Subject: 2014/4429/p

1. Does a "minor material" amendment mean "minor" in relation to the materials used; or as an amendment which is "minor" in relation the scheme itself? See attached photo: 'pre-application - roof pitch & height reduced.' [bottom left drawing changed to bottom right version]. Design & access statement paras 3.3.13 to 3.3.14, following 'pre-app meeting 01' refer to this.

Proposed Block 02 - April 2012, following pre-application discussions with L. Elevational changes and roof pitch and height reduced.

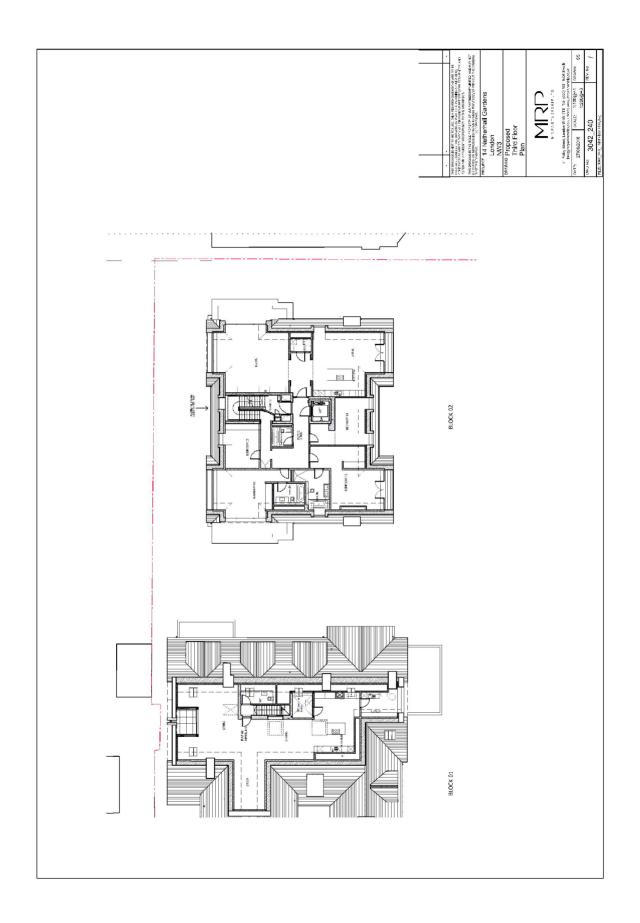
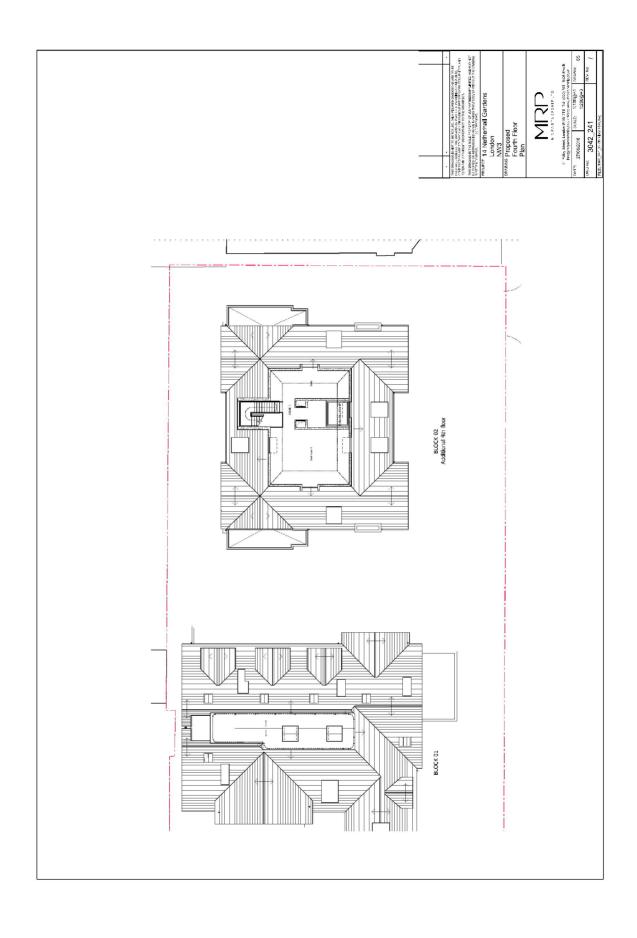
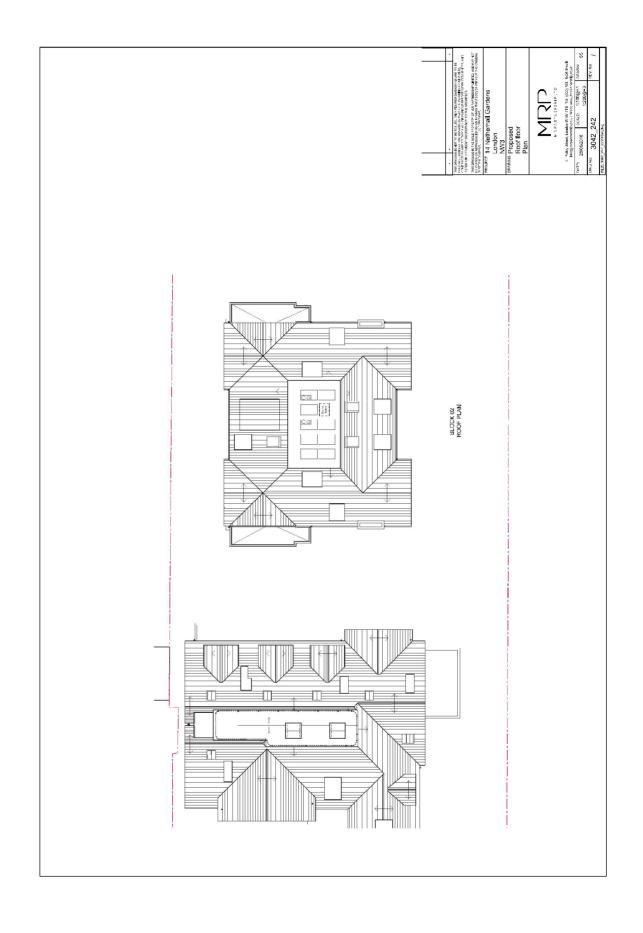
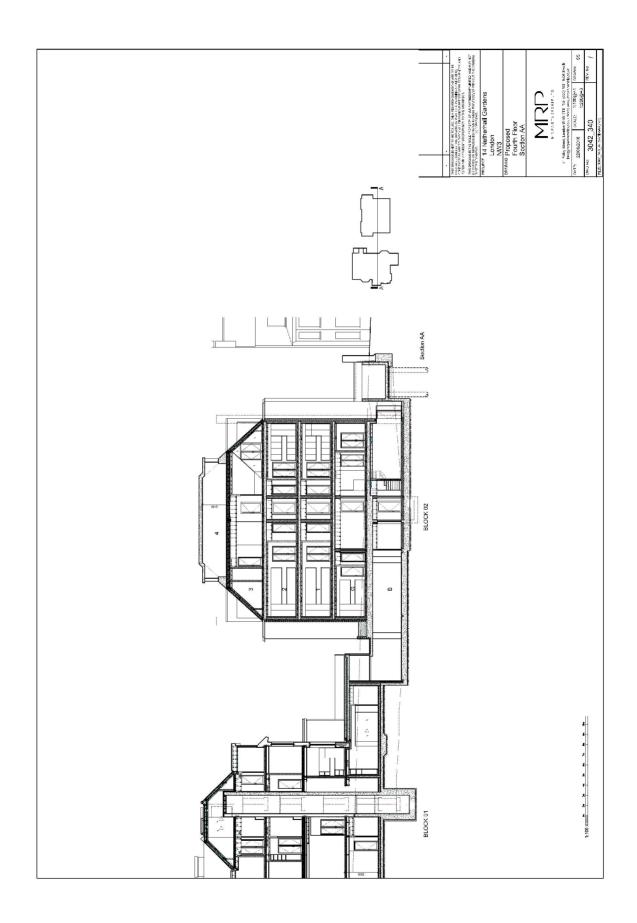
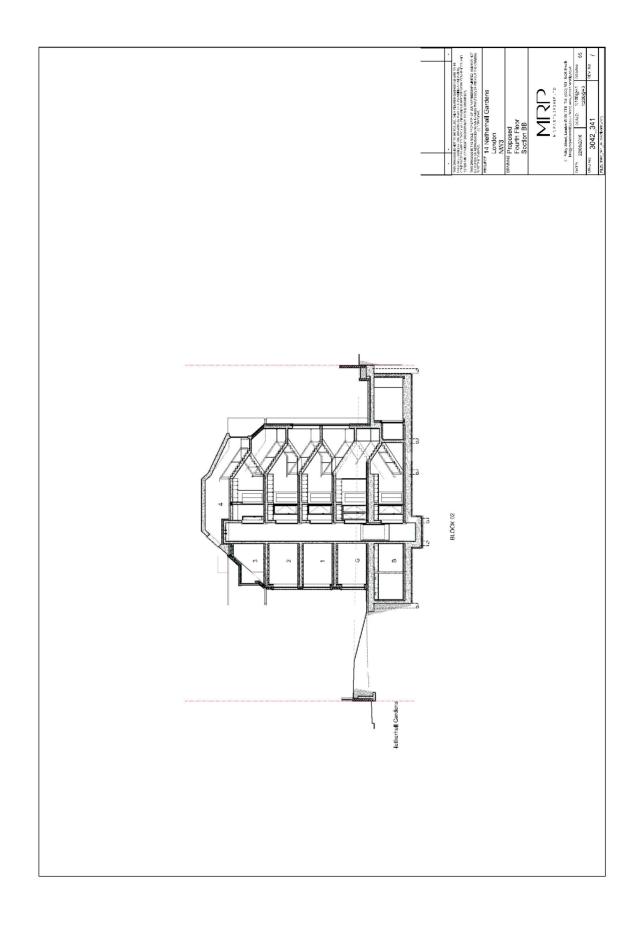
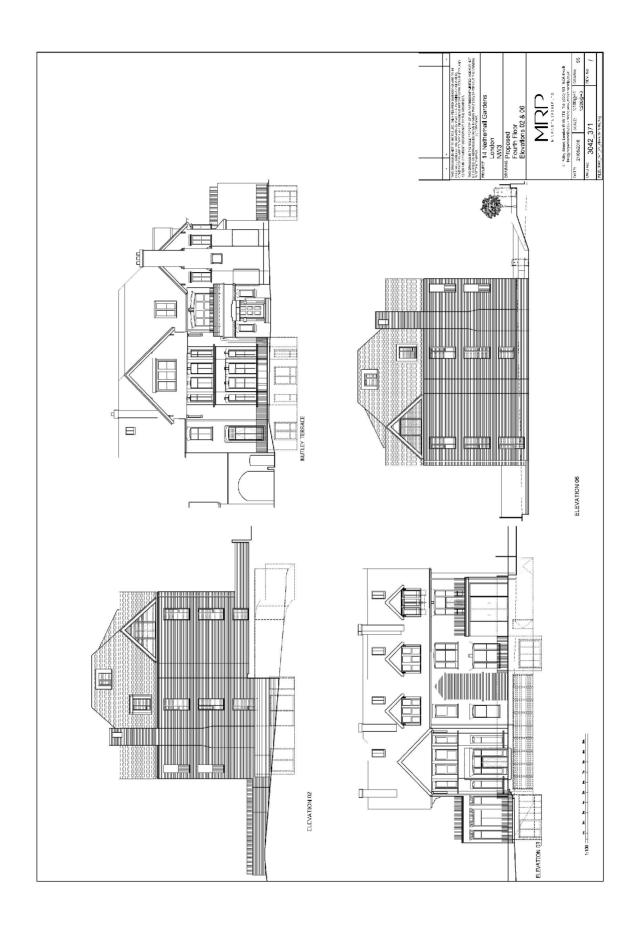
There can be no doubt but that the developers accepted at the first step of their contact with Camden planning, a <u>reduction in height</u> as a precondition for any application for a block of flats in the garden of Otto Schiff House.

What a nerve they have, to have requested <u>raising</u> the roof within a few months of finishing.

Did the developers really think that no one would notice these two increases, from when they had promised at the pre-app meetings to deliver reductions?
